**Section 16 Planning Application under the Town Planning Ordinance (Cap.131) for  
Submission of Layout Plan in “Commercial (2)” Zone for Patchway Holdings (HK) Limited at Inland Lot No. 8945, Causeway Bay**

**Planning Statement – Further Information 3**

**s.16 Planning Application No. A/H7/186 - Departmental Comments**

**Response to Comments**

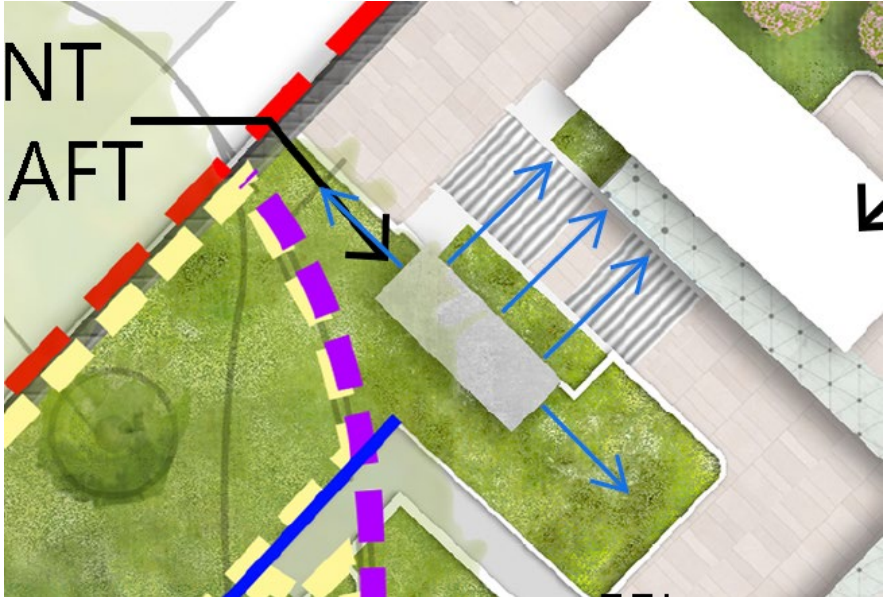
<ul style="list-style-type: none"> <li>- 2/F, Covered Landscape Bridge – Layout of covered planting area and circulation paths is revised.</li> </ul>	Noted. This is correct.
	<ul style="list-style-type: none"> <li>- T3, G/F and 2/F – Additional vertical greening is proposed along the site boundary to the southeast and southwest of T3.</li> </ul>	Noted. This is correct.
